# VTA's BART Silicon Valley Phase II Extension Project

## Twin Bore Update

### Executive Summary

**Figure 2-2 Single Level Back-of-House (BOH) Basement Structure (shown on the left)**

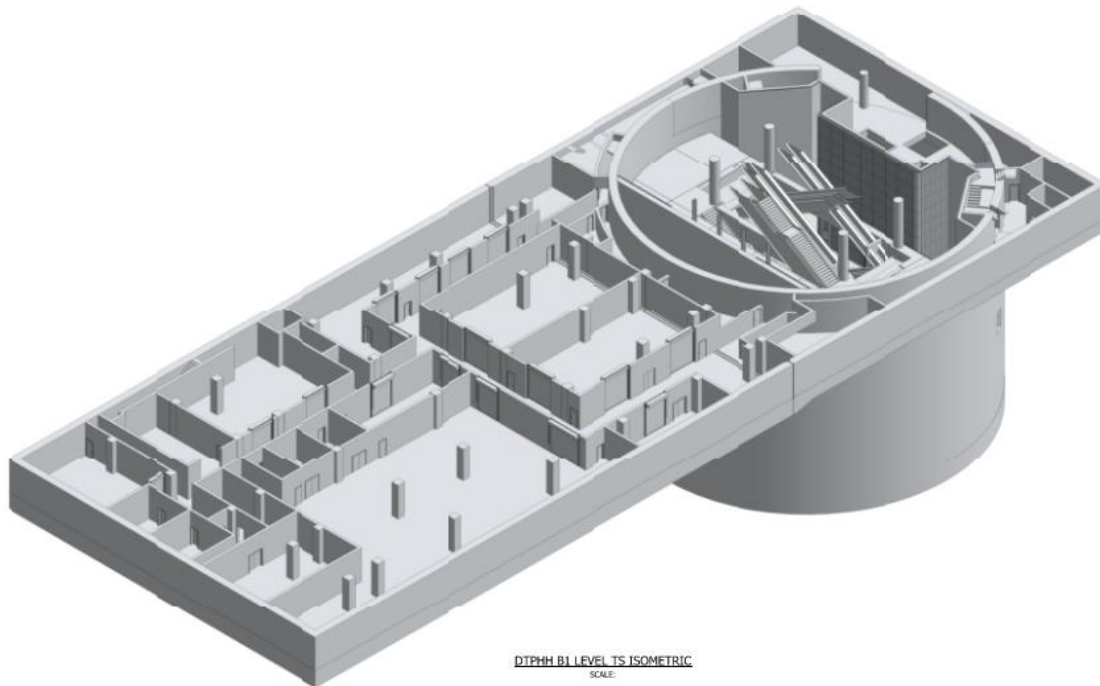
For the DTSJ Station the present parking lot behind the headhouse provide ample space for BOH rooms.

Figure 10 – Single-Bore Twin Track Mid-Size Tunnel

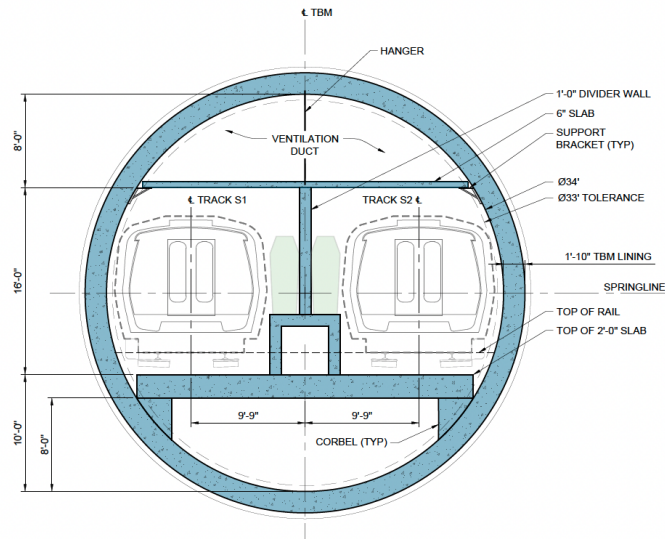
In this concept two mid-size Single-Bore tunnels each is 34'-6" inside diameter and each housing two tracks separated by a dividing wall to meet NFPA 130 requirements will be provided. See Figure 10.

This tunnel configuration provides numerous advantages over the Large Single-Bore and the Twin-Bore:

1. 50% Smaller excavation volume than the Large Single-Bore
2. 47% less concrete than the Large Single-Bore
3. Although larger excavation volume and more concrete than the Twin-Bore, it eliminates the need for mid-tunnel ventilation plants and cross passages

6. Eliminates the two mid-tunnel ventilation plants in the Twin-Bore
7. Eliminates the cut & cover construction of the cross-over in the Twin-Bore
8. Shorter stations foot print and smaller excavation than the Twin-Bore or the Single-Bore

Figure 11 – Potential configuration of the DTSJ station

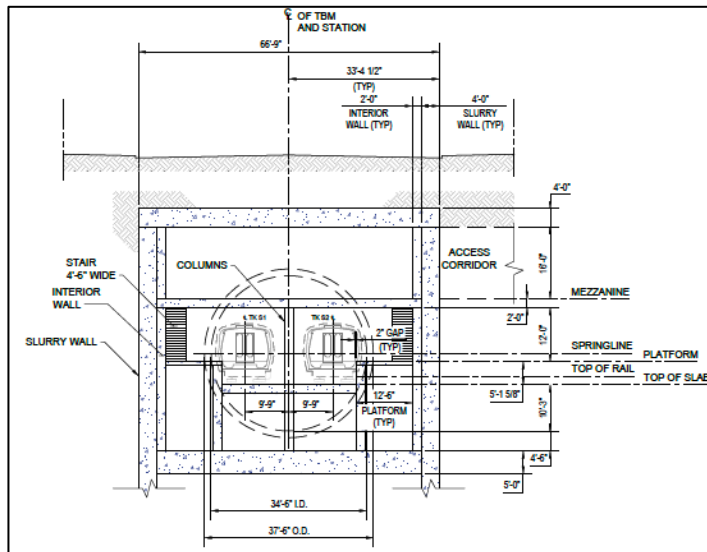
It is anticipated that two TBMs with an outside diameter in the range of 38.5ft (11.7m) will excavate the two tunnels one from the East Portal and one from the West Portal meeting at the Downtown Station. All underground stations will be constructed using the cut and cover method with side platforms. The alignment will follow the southern alignment of Diridon Station to avoid impacting Caltrain tracks. The two TBMs will terminate at the Downtown Station. This concept is being evaluated by Level 3 Cost Saving Task Force. Figure 11 illustrate the downtown station configuration.

With this configuration the tunnel alignment will be raised to provide a cover over the tunnel of about 35 to 40 ft. This will raise the elevation of all stations, reduce the station excavation, minimize the vertical circulation elements and their lengths, and reduce travel time of the passengers under normal operating scenario and passengers' evacuation under a fire scenario. With today's technology of sophisticated tunnel boring machines, the required cover over the tunnel can be reduced to about one tunnel diameter. Although detailed analysis of the type of TBM required, with the variability of the ground and the high ground water pressure, it is suggested that multi-mode or variable density TBMs be used.

Figure 12 – Location of DTSJ Station

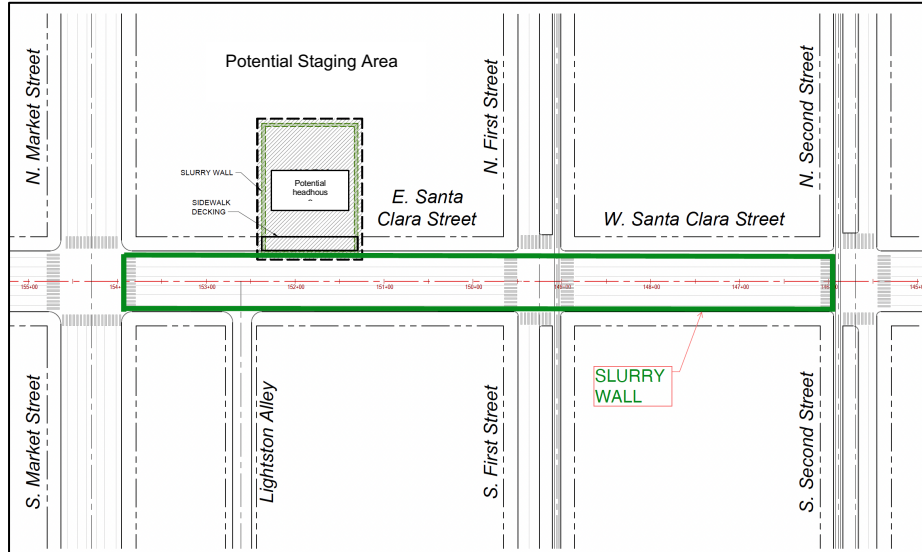
This proposed station configuration is optimal in which the station headhouse will remain as it is in the present design and the connection between the headhouse and the station mezzanine will be similar to the present design. The platforms will connect to the mezzanine with a number of stairs along the station wall to meet the passenger load. Using 2-unit stairs and 8 ft clear from the edge of the stair, each platform width will be 12'-6" wide. However, with minor adjustment to the track layouts as they enter the station, the platform width can be increased to 15'-3". The station box will be 66'-9" wide by 780' long. It will fully fit within Santa Clara Street ROW curblines with no impact on the sidewalks, and the vaults under the sidewalks. Under this configuration, the station excavation length under Santa Clara will be 780ft to accommodate the platforms length of 700 ft plus end of the platform facilities of 40 ft on each end. The station will be positioned between East of N. Market Street and West of N. Second Street. See Figure 12. The headhouse will be in the lot between N. Market Street and N. First Street. With this configuration no impact on the utilities or the traffic on Market Street and Second Street. Staging site will be located at the headhouse site and the parking lot behind it as planned in the present design concept. Construction sequencing was developed to minimize impact on the traffic and community during the construction of the support of excavation using staged construction. In every stage, we provided two lanes of traffic (one east bound, and one west bound) occupying a width of 24 ft and provided a work zone areas with a width of 44ft. See figure 13 for work zones 2A and 2B as illustration to the staged construction.

Figure 13 – Staged construction of DTSJ station

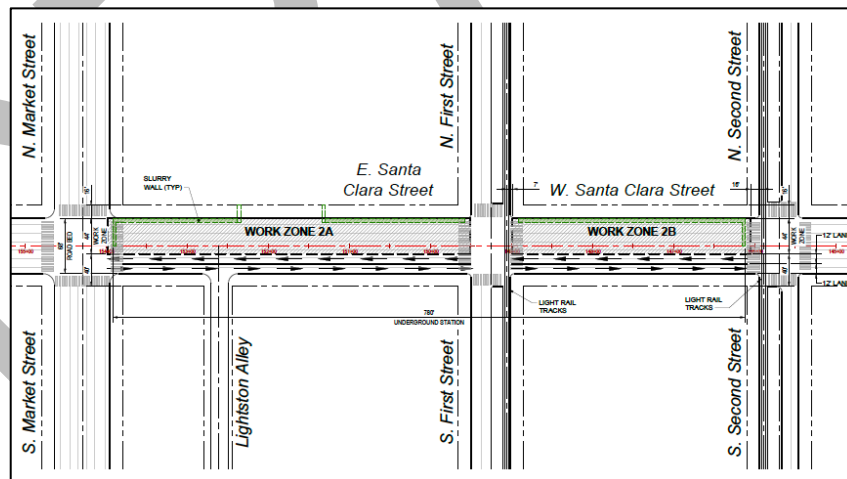
It is anticipated that two slurry wall rigs will be used to construct the perimeters of the excavation in stages. The slurry wall panels are assumed to be 18 to 25 ft wide, 4 ft thick and 140 ft deep to ties into impervious soil layer for groundwater control. Street decking beams will be installed within each work zone and precast decking panels will be provided. Utilities can be supported in place from the decking beams. See example in Figure 14. Upon the completion of the installation of the support of excavation and decking, the traffic will be restored to normal. Station excavation, concrete work, interior structures, finishes, mechanical/electrical work, etc. will be done under the protection of the street decking. The station entrance site and the adjoining construction staging area will be used for access, material delivery, and muck removal. The slurry plant will be located at this site to support all work zones.

Upon the completion of the construction, the decking beams will be removed, and the street will be restored to its original configuration in stages always maintain through traffic on Santa Clara Street.

Figure 15 – DTSJ Station using SEM tunnelling

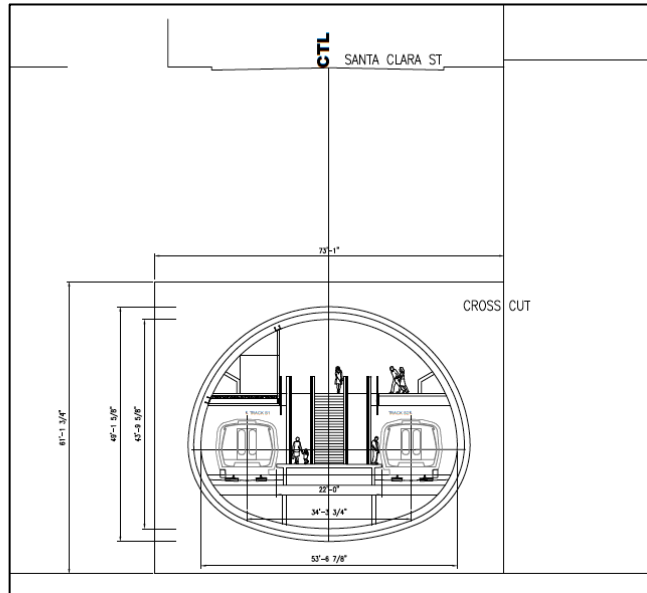
The Sequential Excavation Method (SEM), referred to it as the New Austrian Tunnelling Method (NATM), is a tunnelling method using mining techniques in which the excavation is carried out in small headings and short round lengths in order to maintain its stability. A recent project using the SEM method is the Chinatown Station as part of the Central Subway in San Francisco. Figure 15 illustrate a potential configuration of the SEM tunnelling of DTSJ station. From the headhouse site, a crosscut will be constructed using SEM tunnelling across Santa Clara Street, then SEM tunnelling of the station progress from the crosscut east and west to complete the excavation of the station. Initial support of lattice girders and shotcrete will be installed after every round of every heading. It should be noted that the station can be designed with a center platform as shown in Figure 15, or with side platforms. Also, the TBM tunnels can stop at the stations or if preferred and based on the construction schedule, one of the TBM can progress through the station area

excavating significant volume of the station. The remaining volumes will be excavated using the SEM tunnelling method similar to the construction of Chinatown station in San Francisco. See figure 16. Figures 17 illustrates the sequential excavation method:
